August 8, 2017 Project Reference #16153

**Subject: Addendum to the Site Investigation Status Report, Proposed Additional Sampling and Analysis Plan & WDNR Technical Assistance Request (Revised July 2017)**
**Solenis, LLC, 5228 N. Hopkins Street, Milwaukee, WI 53209**
**WDNR BRRTS No. 02-41-577350**
**WDNR FID No. 241041900**

**From:** Hnat, John J - DNR <John.Hnat@wisconsin.gov>
**Sent:** Friday, July 28, 2017 10:54 AM
**To:** Tim Wimmer; Mafizul Islam; Cory Katzban; James Faulstich (JFFAULSTICH@SOLENIS.COM); rladewig@solenis.com
**Cc:** Mylotta, Pamela A - DNR
**Subject:** Solenis July 27th, 2017 Meeting
**Attachments:** Solenis Fig 8.pdf

FIGURE
9

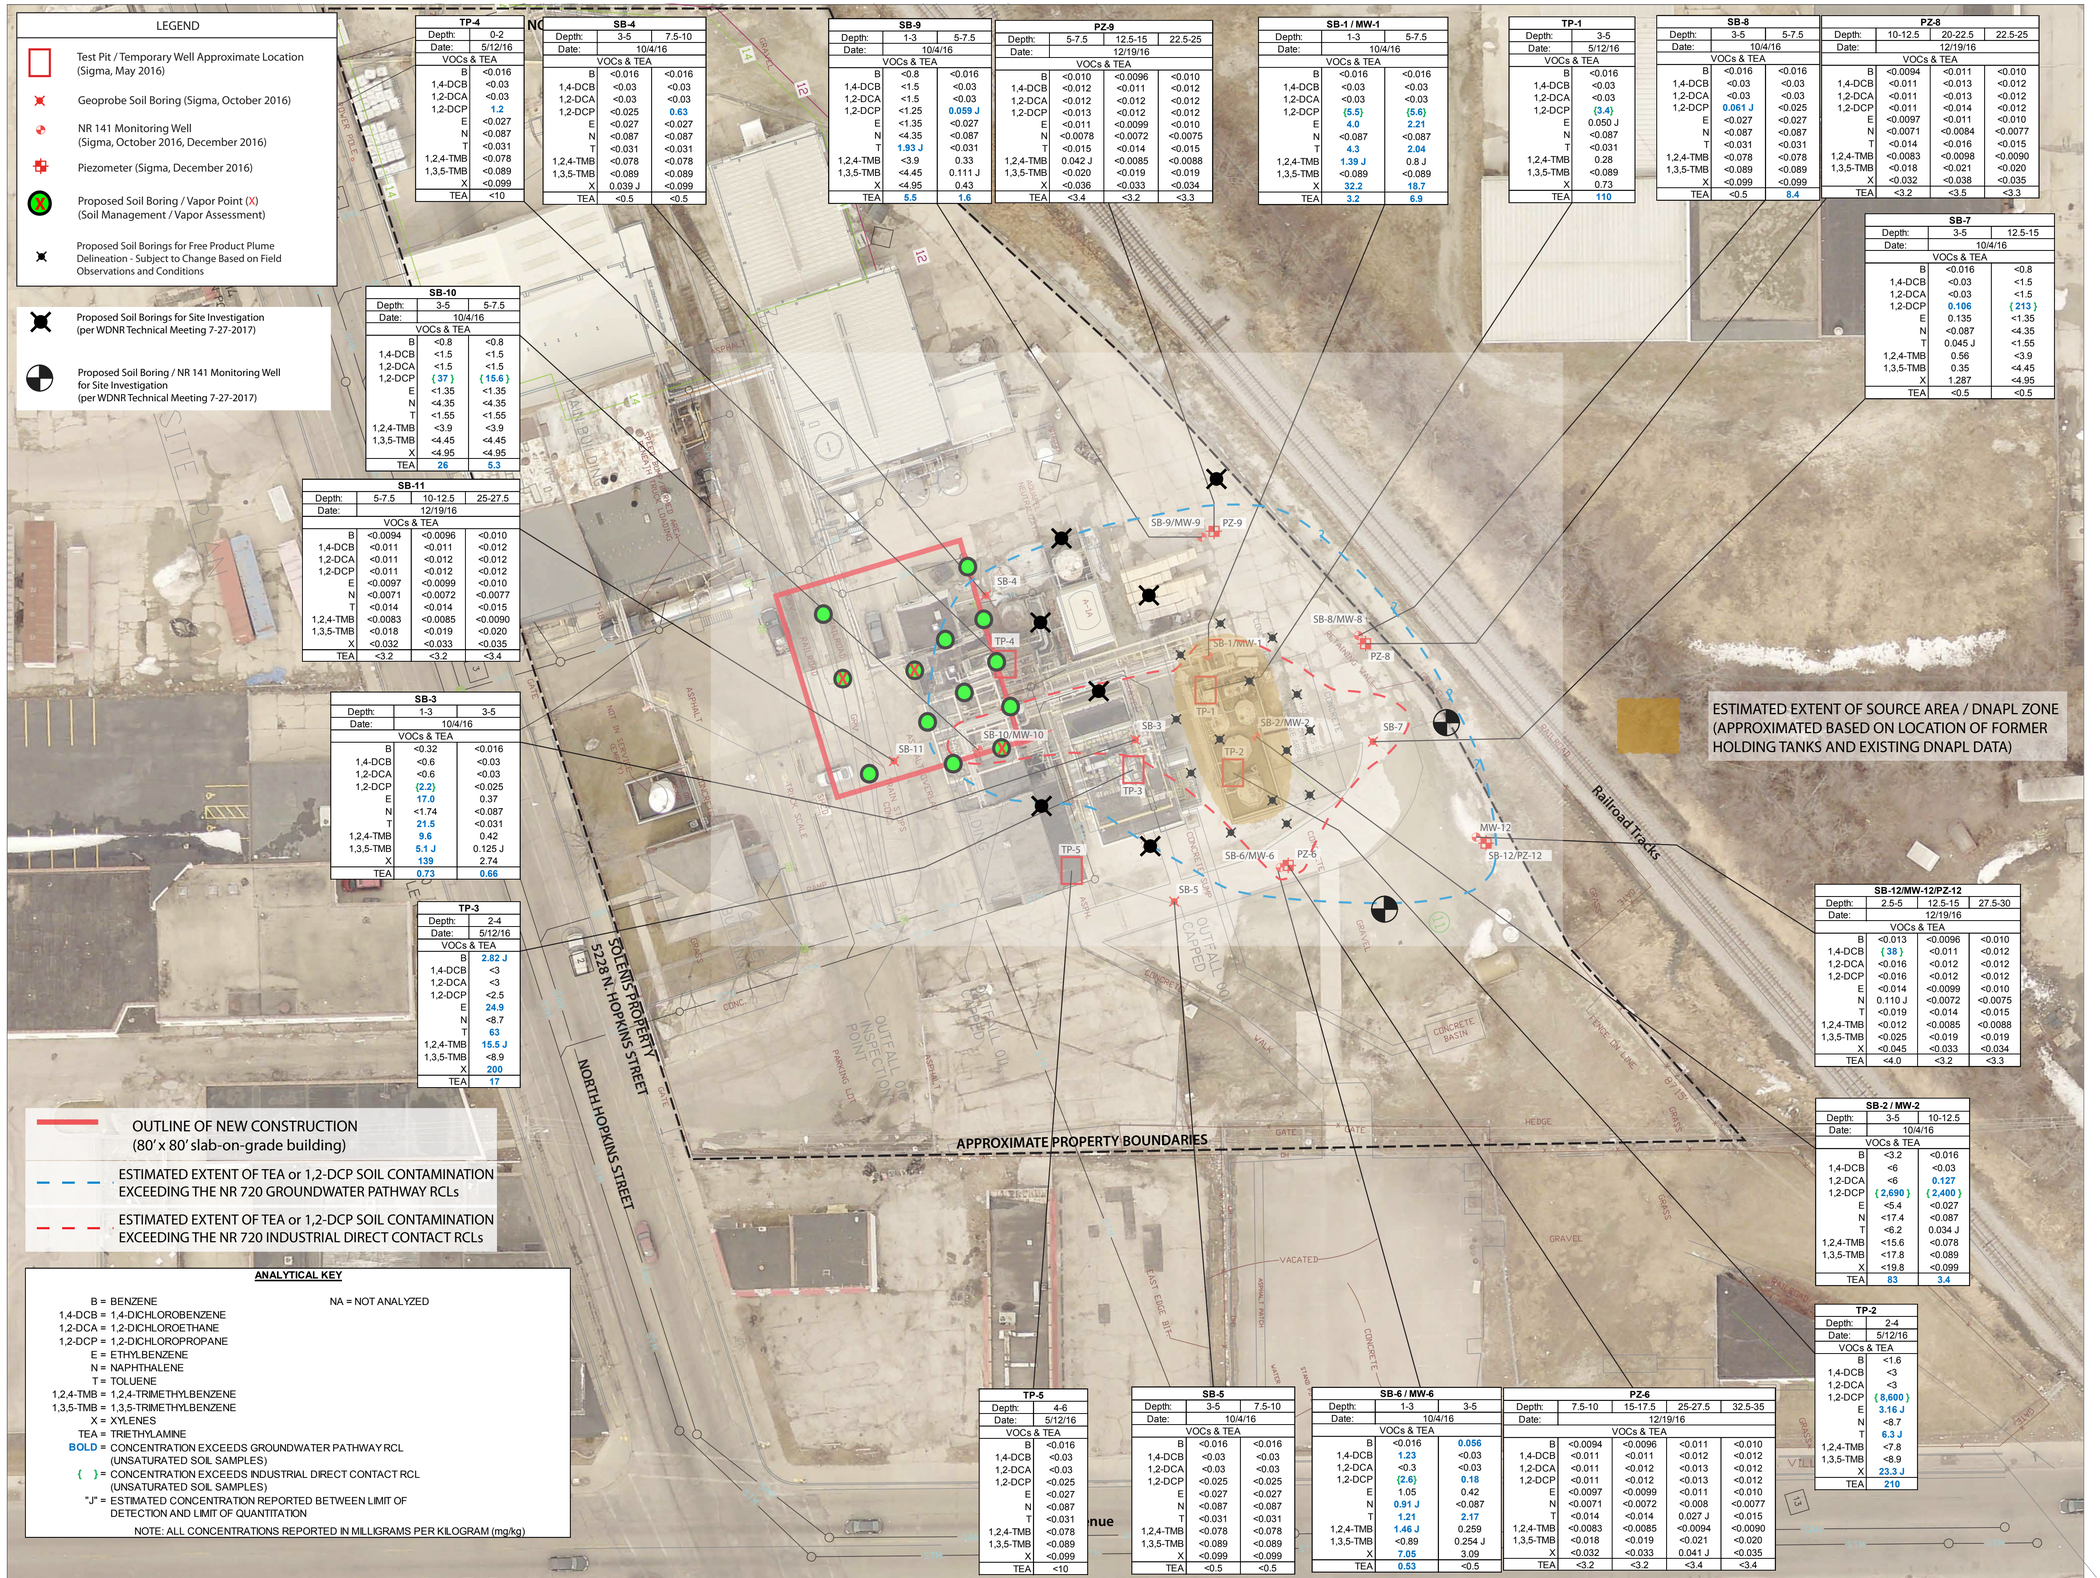
- See attached map Figure 8 for references below.
- The DNR agrees that the free product should be bailed out of groundwater monitoring wells MW-1 and MW-2 prior to abandoning the wells.

- We recommend that over drilling and replacing MW-1 and MW-2 should be delayed until the additional soil sampling and defining the extent of free product over the area of the former ASTs be completed first. This would generally provide information where additional wells may be placed in order to recover free product. It would also present a clearer understanding on how free product decreases in concentration values towards the other monitoring wells.

- We recommend additional investigation downgradient from soil boring location SB-7. SB-7 indicates 1,2-DCP increasing in concentration from 0.156 ppm at 3-5 feet to 213 ppm at 12.5-15 feet. The groundwater table varies from 12 feet (MW-8) to 3.3 feet at MW-12. The groundwater contamination plume may be migrating east of SB-7. Therefore, we recommend additional soil/groundwater sampling in this area and possibly a NR 141 groundwater monitoring well to continue defining the GW plume.

- The area between the former AST and where the new building foundation is proposed has limited soil sampling. Triethylamine (TEA) is above the groundwater pathway RCL in SB-8, SB-9, SB-10, SB-3, and TP-3. Additionally, there are some petroleum compounds above their groundwater pathway RCLs in TP-3, SB-3, SB-9 ("J" flag for toluene), and SB-6. We recommend additional soil sampling in the areas south of SB-10 and west of SB-3/TP-3; north of SB-3 and SB-1 towards SB-4 and SB-9 for VOCs for degree and extent.

- Over-drill and abandon existing monitoring wells MW-1 and MW-2. The replacement of these wells will be postponed until further investigation and analysis of the extent of the apparent free product plume is completed. Sigma will attempt to recover free product from these wells prior to abandoning and sealing.

- Advance additional soil borings in the following areas to further define the degree and extent of volatile organic compound (VOC) and triethylamine (TEA) impacts to soil and groundwater, as well as collect additional data to fill existing spatial data gaps:

- *East of SB-7*: one soil boring, convert to WDNR Ch. NR 141 monitoring well;
    - *South / west of SB-10 and SB/TP-3*: two soil borings;
    - *North of SB-1 and SB-3, toward SB-4 and SB-9*: four soil borings;
    - *North of SB-9*: one soil boring; and,
    - *South of SB-6*: one soil boring, convert to NR 141 monitoring well.

Please note, given the expanded soil boring and sampling program with respect to the overall site investigation (described above), the number of soil borings proposed within the footprint of the new boiler house building has been revised.

The attached **Figure 9** depicts the locations of the additional soil borings / monitoring wells proposed for further defining the degree and extent of VOC and TEA impacts at the site, as well as the soil borings within the free product area and new building footprint.
